**AERONAUTICAL CHARTING FORUM**  
**Instrument Procedures Group**  
**April 26, 2011**

**FAA Control # 11-01-296**

**Subject: Magnetic Variation Differences and FMS Systems**

# BULLZ ONE RNAV ARRIVAL (BULLZ.BULLZ1)

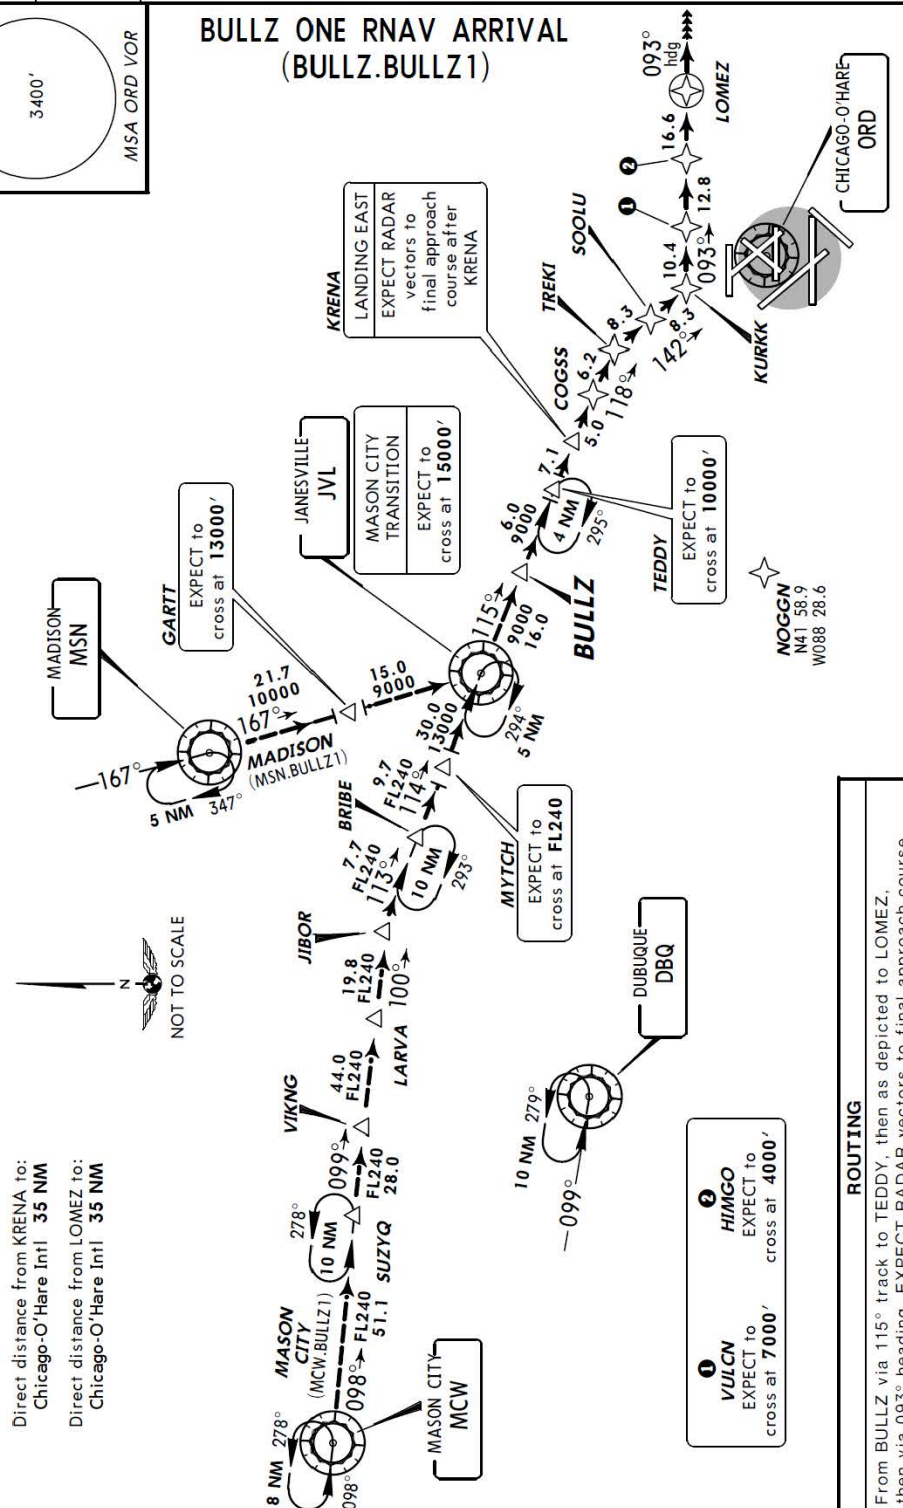
The Janesville VOR (JVL) magnetic variation is 3 degrees East (epoch year 1965). Departing JVL to BULLZ the true course is 112 -3 East (East is least, West is best) yielding a magnetic course of 109. The KORD magnetic variation is 3 degrees West (epoch year 2010). So on the RNAV arrival JVL to BULLZ is a true course of 112 +3 West to yield a magnetic course of 115.

In FMS aircraft that have database holding patterns, it appears that they are reverting to a magnetic variation that is different from the charted pattern. In particular, the B737 was noted to bring up the TEDDY holding pattern for the BULZZ.BULLZ1 arrival that matched the JVL.JVL5 conventional arrival rather than the charted BULZZ arrival.
